# UNITED STATES PATENT AND TRADEMARK OFFICE

APPLICATION NO.	FILING DATE	FIRST NAMED INVENTOR	ATTORNEY DOCKET NO.	CONFIRMATION NO.
10/699,335	10/31/2003	Anthony J. Cafferata	J-3763	5399
28165	7590	04/04/2006	EXAMINER	
S.C. JOHNSON & SON, INC. 1525 HOWE STREET RACINE, WI 53403-2236			FIDEI, DAVID	
			ART UNIT	PAPER NUMBER
			3728

<b>Office Action Summary</b>	<b>Application No.</b>	<b>Applicant(s)</b> 	
	10/699,335	CAFFERATA ET AL.	
	<b>Examiner</b>	<b>Art Unit</b>	
	David T. Fidei	3728

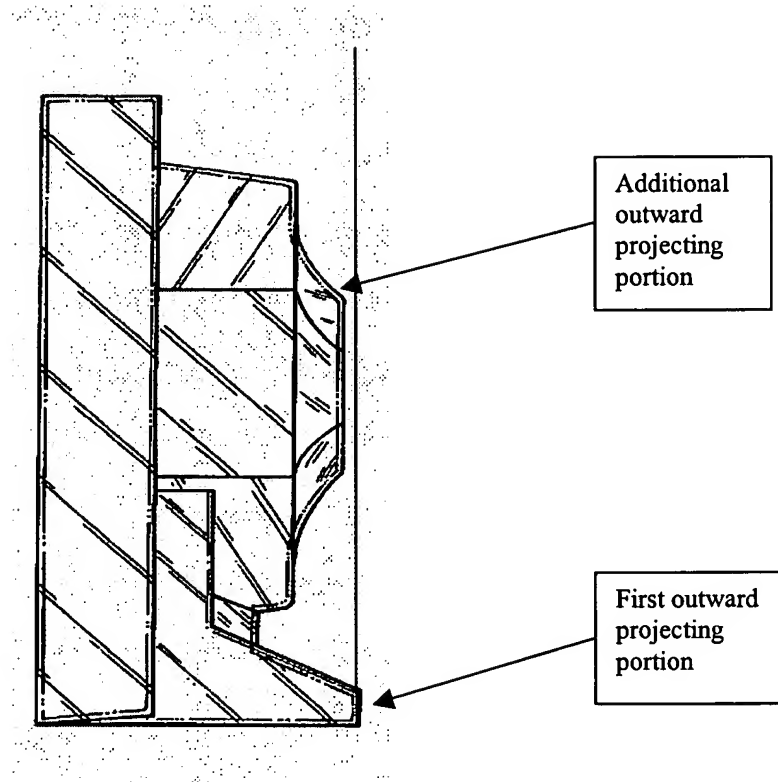
4. Claims 13 and 14 are rejected under 35 U.S.C. 102(b) as being anticipated by Perkins (Patent no. 4,781,289). As to claims 13 and 14 a package for containing and displaying at is disclosed comprising a back panel (12), and a front panel (18) attached to said back panel, wherein said front panel comprises a blister pack formed of plastic and including a first outward projecting portion (22) in a bottom portion of said blister pack and at least one additional outward projecting portion (20) having a depth and shape conforming to at least a portion of said at least one article, wherein at least a portion said first outward projecting portion extends widthwise at least a substantial portion between a first side of said blister pack and a second side

of said blister pack, and has a depth outward sufficient to allow said package to stand substantially upright. As described in col. 3, lines 7-9, the depth of the at least one additional (20) projection is equal in depth to the greatest depth of the first portion (22).

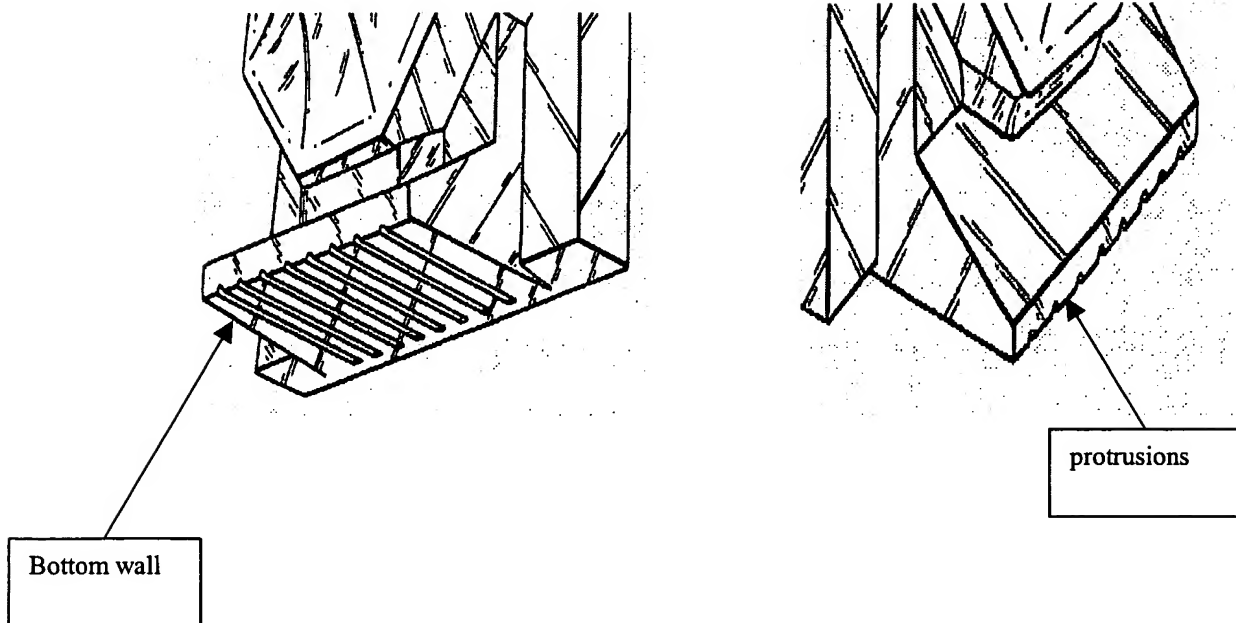
As to claim 5, a package according to claim 1 wherein said first outward projecting portion includes a bottom wall having integral therein at least two spaced apart

downward protrusions, see the figure below

As to claim 6, a blister pack is shown according to claim 2 wherein said first outward projecting portion includes a bottom wall having integral therein at least two spaced apart downward protrusions. As shown above there are a plurality of protrusions in as much as is claimed.

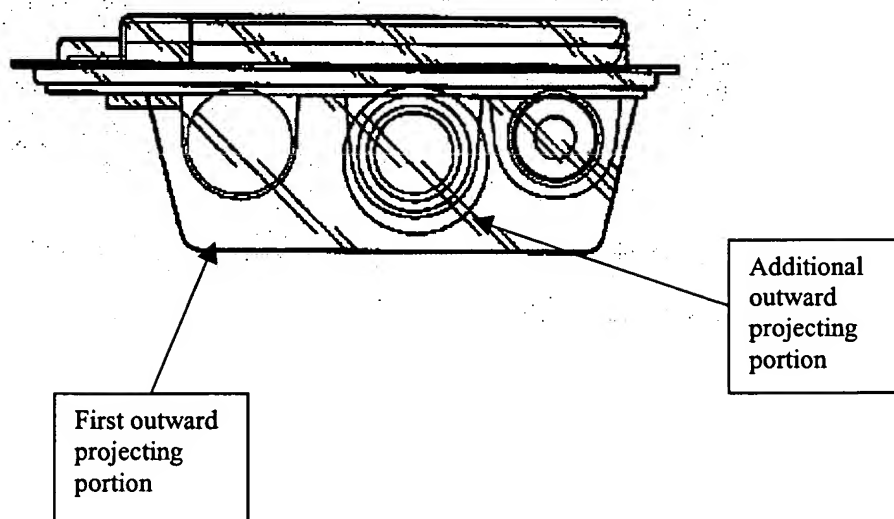
As to claims 7 and 8, a package according to claims 1 and 2 is shown where the first outward projecting portion includes a front wall of uniform depth.

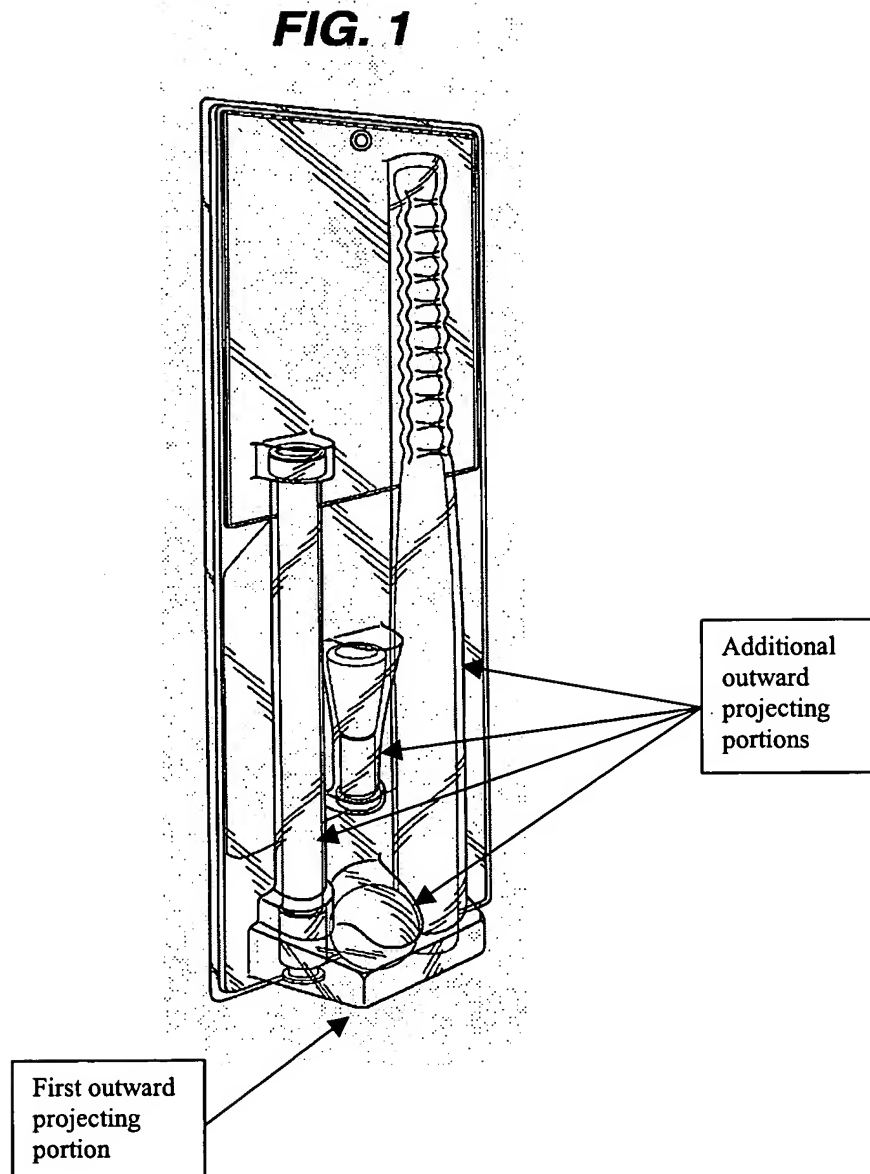
As to claims 9 and 10, one of said portions of non-uniform depth is a wall of one of said at least one additional outward projecting portion

As to claims 11 and 12, the first portion is substantially rectangular when view from the front side in as much as is claimed.

As to claims 11 and 12, the first portion is substantially rectangular when view from the figure on the previous page in as much as is claimed.

As to claim 15 and 16, a package is shown in the figure on page 7 where said at least one additional outward projecting portions are present, on either side of the middle additional projection portion, wherein said two of said at least two additional outward projecting portions are of different depths from each other.
